**ITEMS RECEIVED AFTER THE PRODUCTION OF THE REPORT
FOR THE PLANNING COMMITTEE
TO BE HELD ON 14 JANUARY, 2016**

LATE ITEMS FOR COMMITTEE

COMMITTEE DATE : 14 January 2016

Photographs of Partial Collapse to Excavations

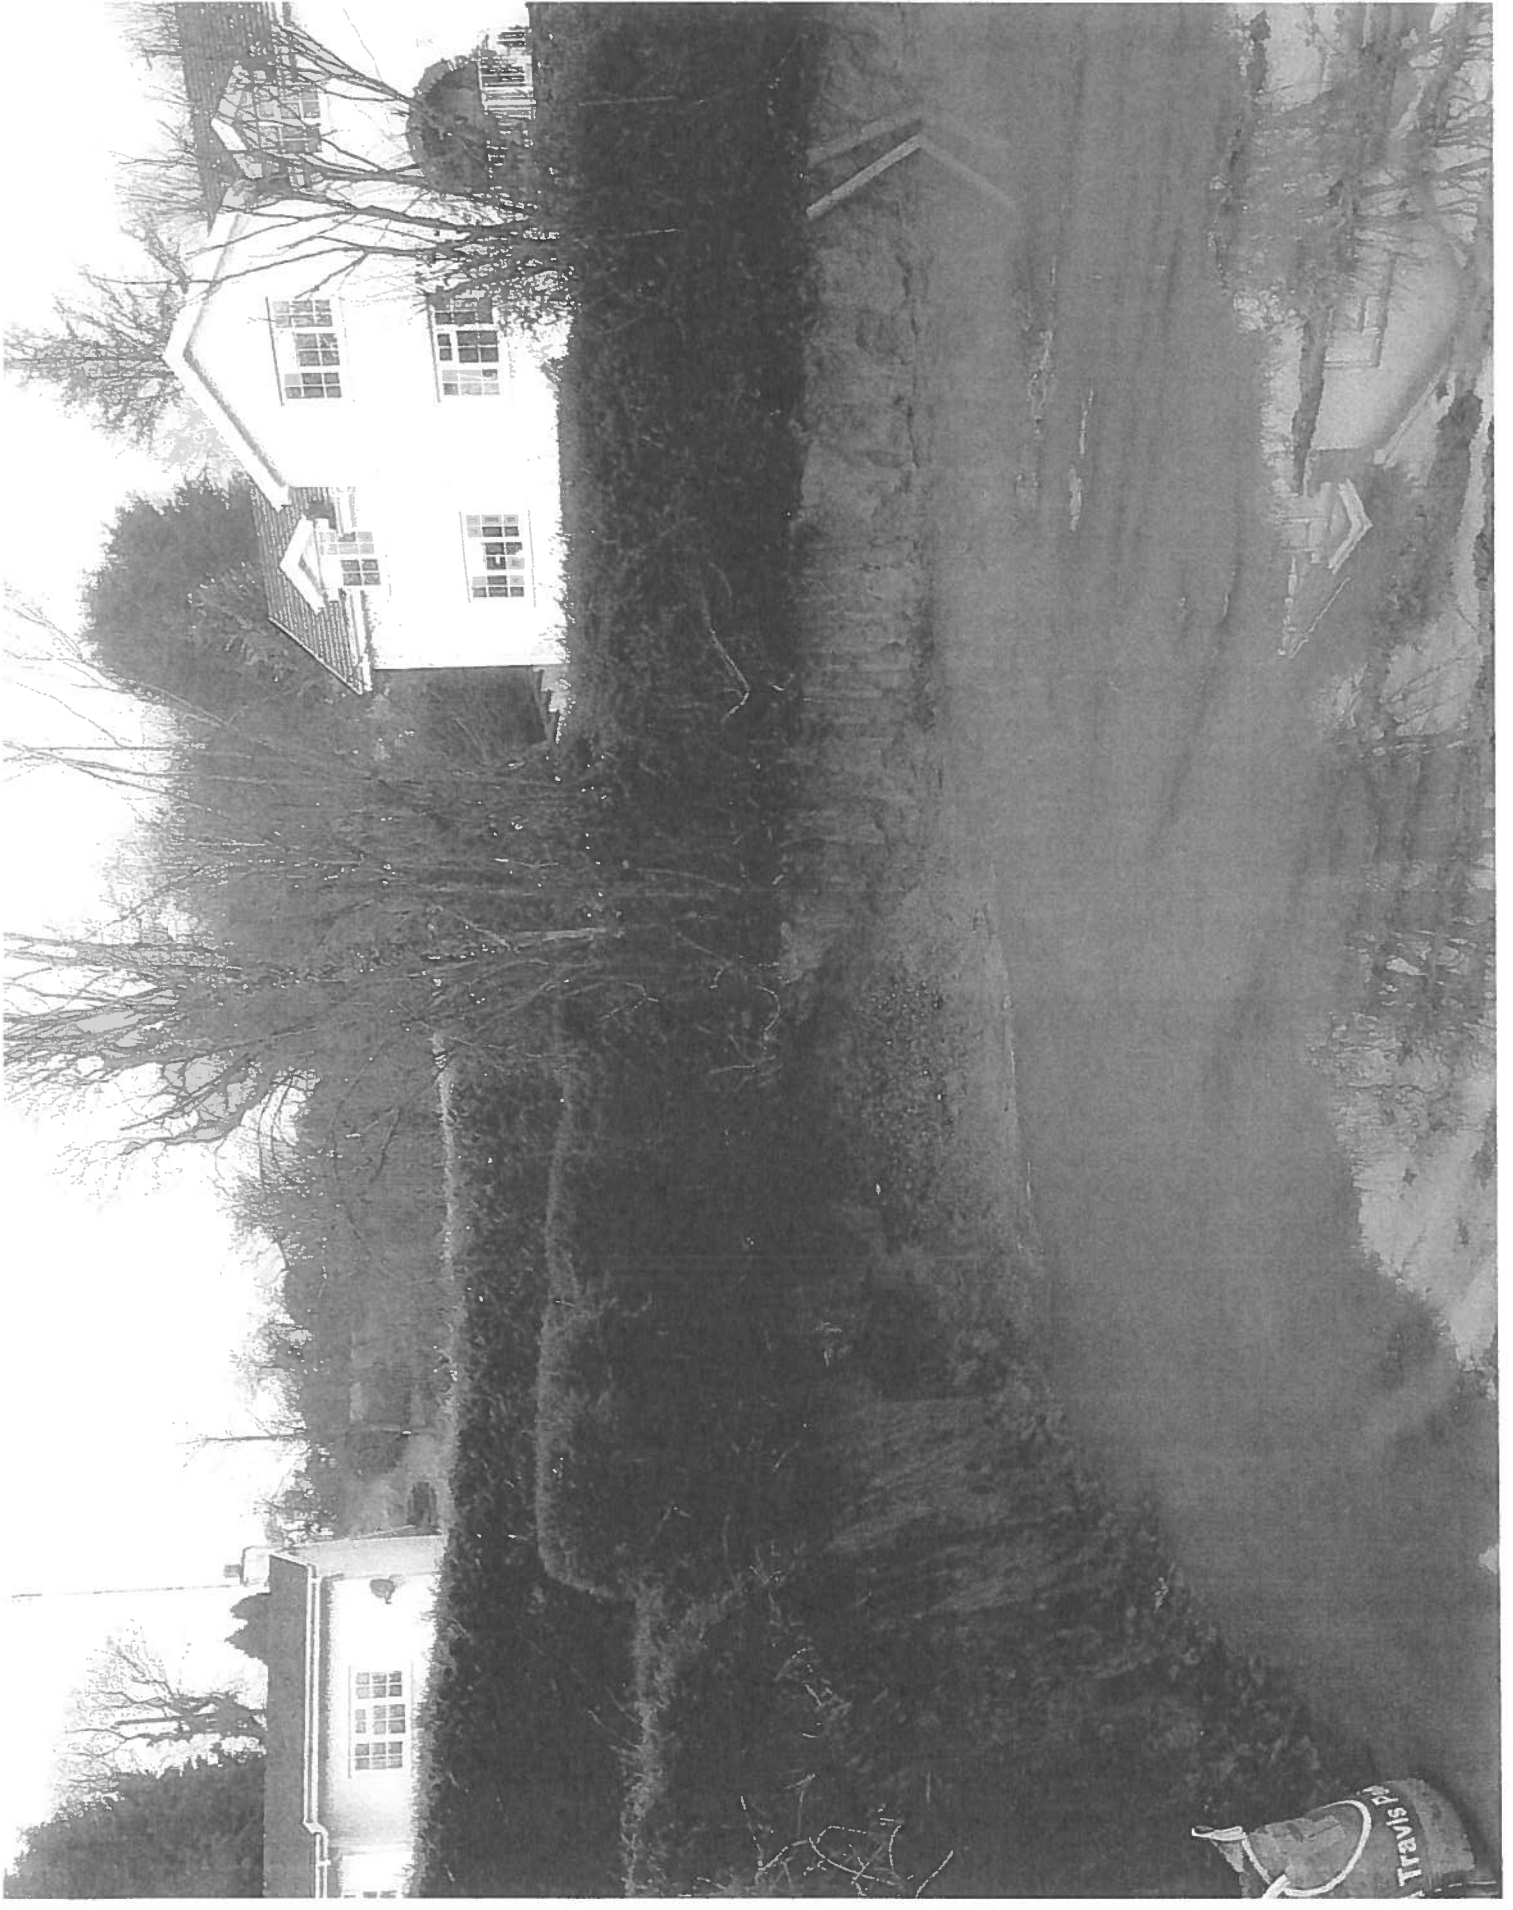
- 4.1.9 We note that subsequent to our initial inspection, that some partial collapse of the excavations has already occurred.
- 4.1.10 It is our opinion that the Planning Authority would require details of the boundary treatment as part of the Planning Application as this will have a material effect on the visual appearance of the site.

PROPOSED SITE PLAN

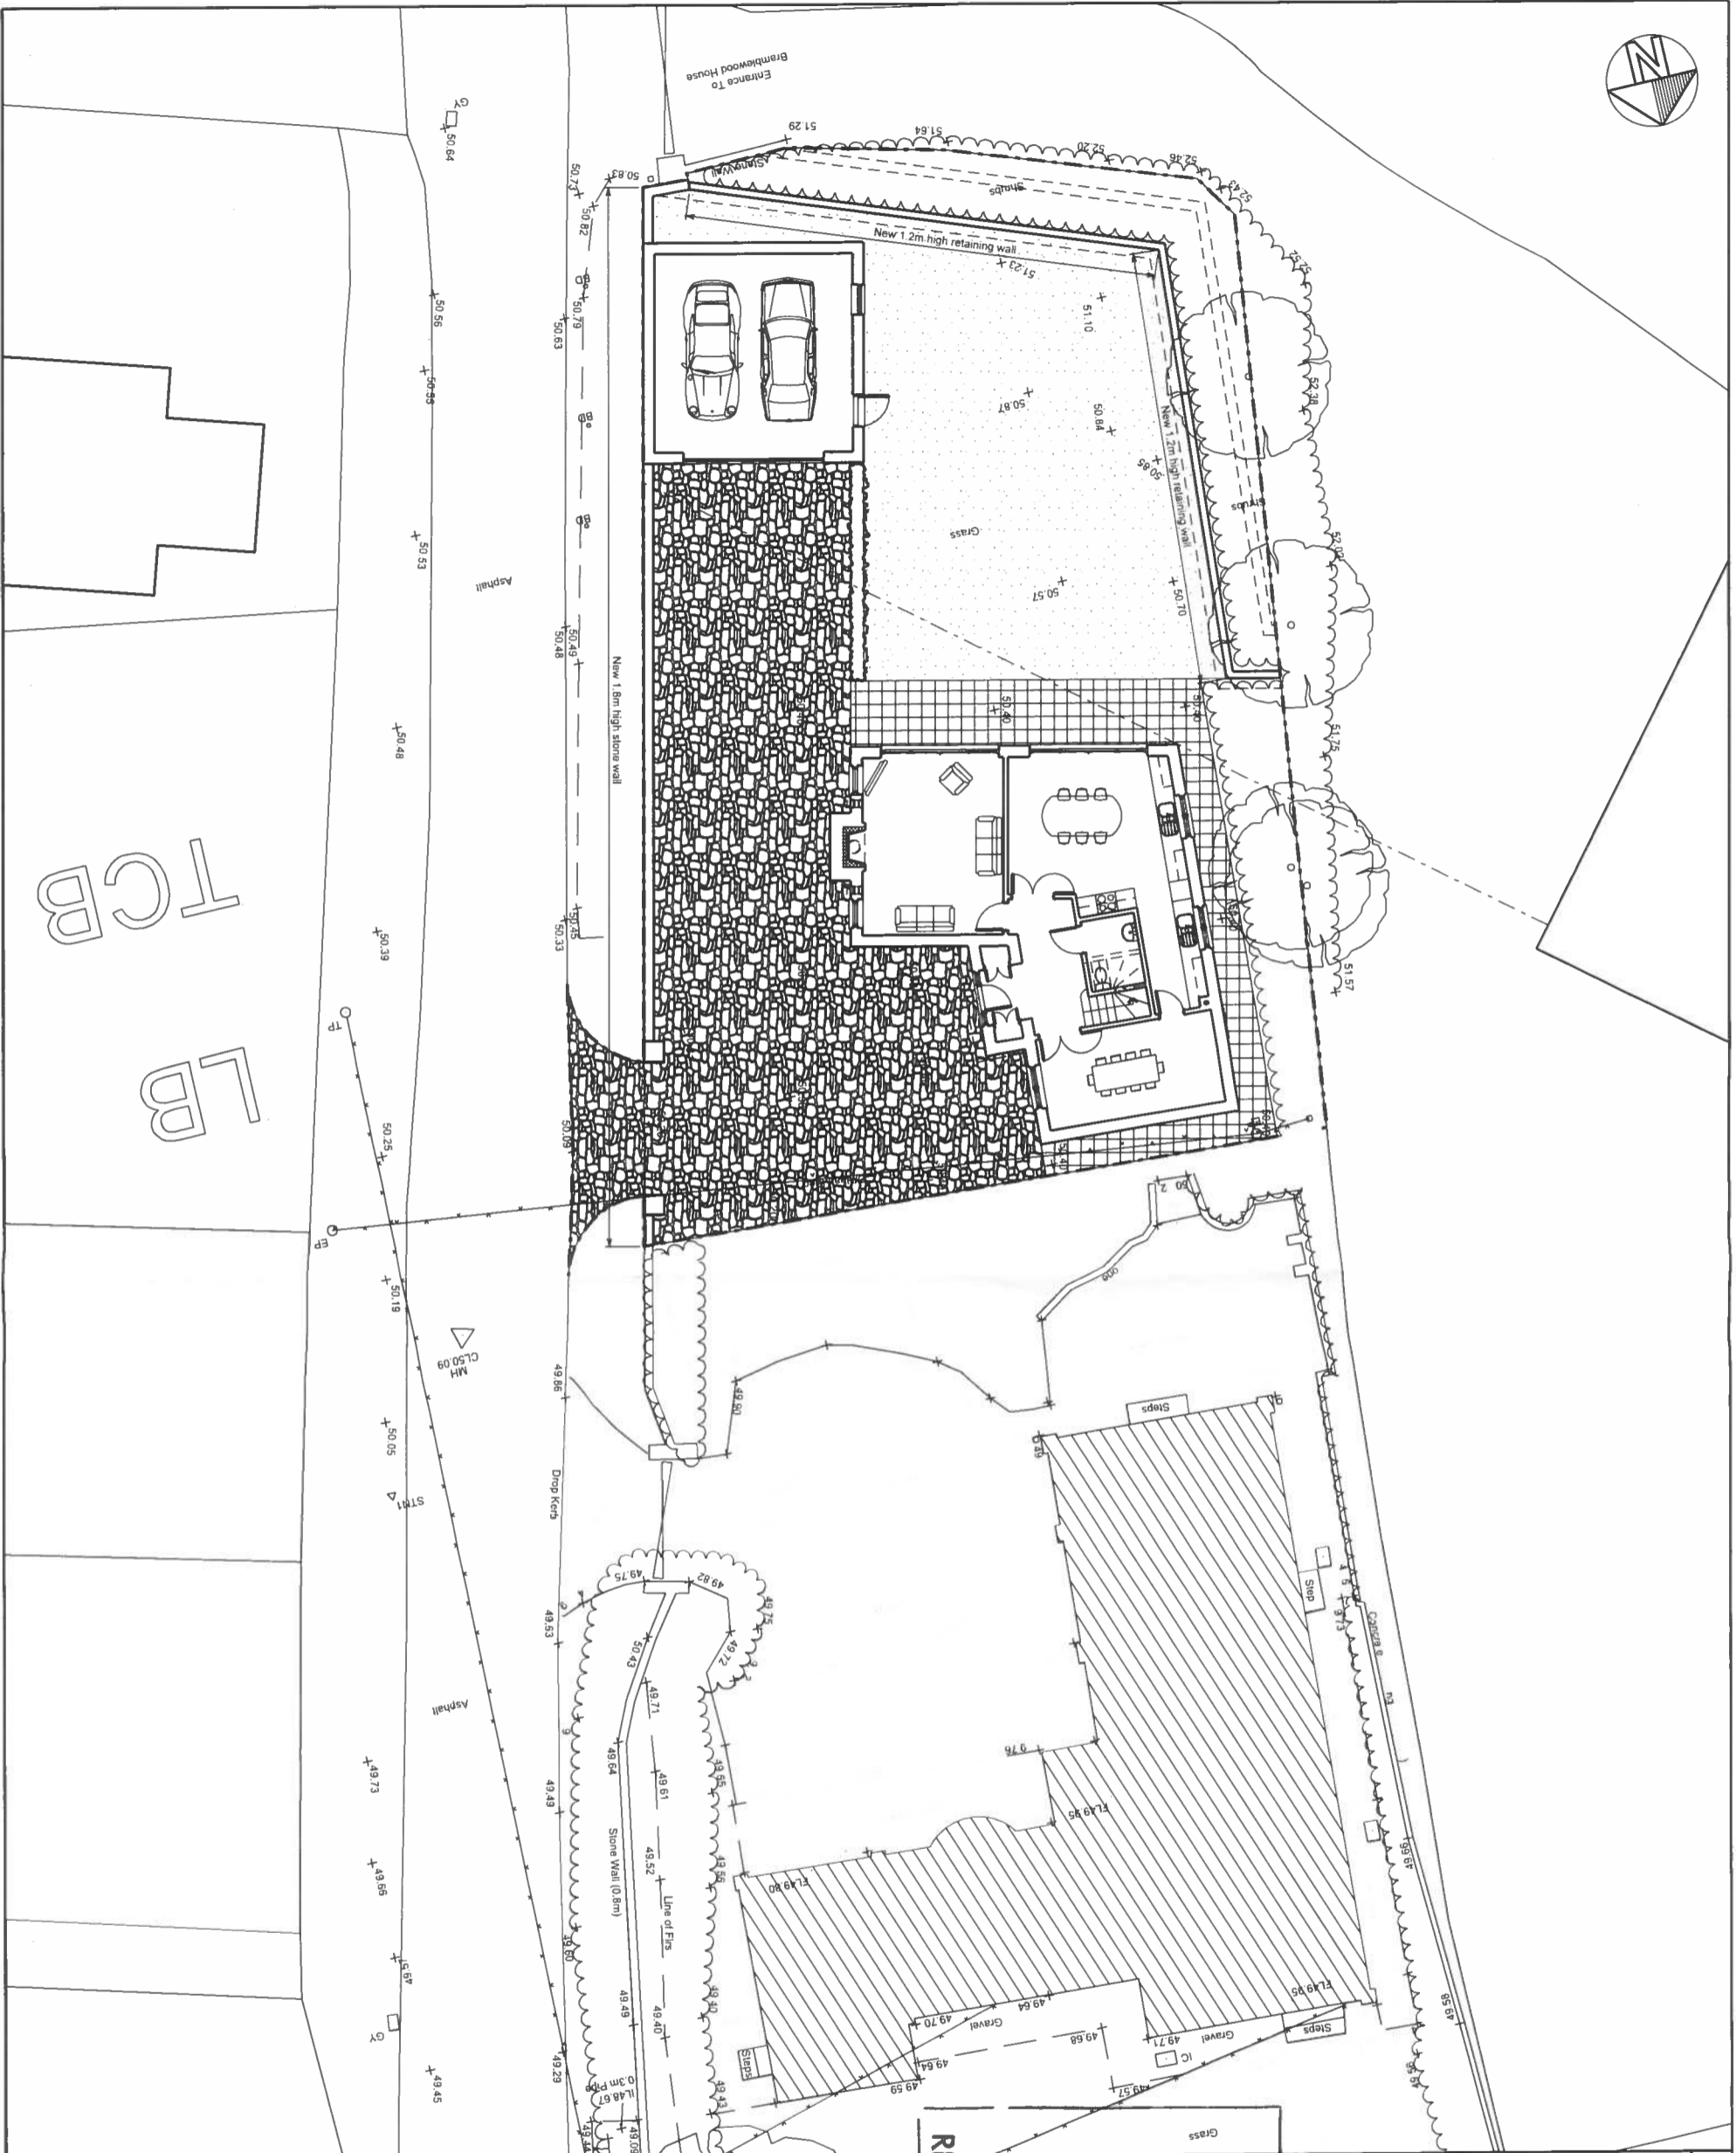
Revised plan received (DP 110A) of proposed layout to include 1.2m retaining wall towards the southern and western boundary of the site. The area for landscaping has also been amended as a result of the retaining wall being included. Structural calculations have also been submitted regarding the retaining wall.

REVISION	DESCRIPTION	BY	DATE
A	Retaining wall added in garden and garage moved to north	RDP	07.01.16

2. The development shall be carried out in accordance with the following approved plans and documents: DP 310 A, DP100, DP110A, DP300A, DP350, Design and Access Statement, Calculations for 'Block Retaining' (Tedds) and DP101;

15. Notwithstanding the submitted information, full details of the retaining wall as indicated on plan DP110 A, including materials and dimensions, shall be submitted to and approved in writing by the Local Planning Authority. The retaining wall shall be fully implemented in accordance with the approved details prior to first beneficial occupation of the dwelling hereby approved.
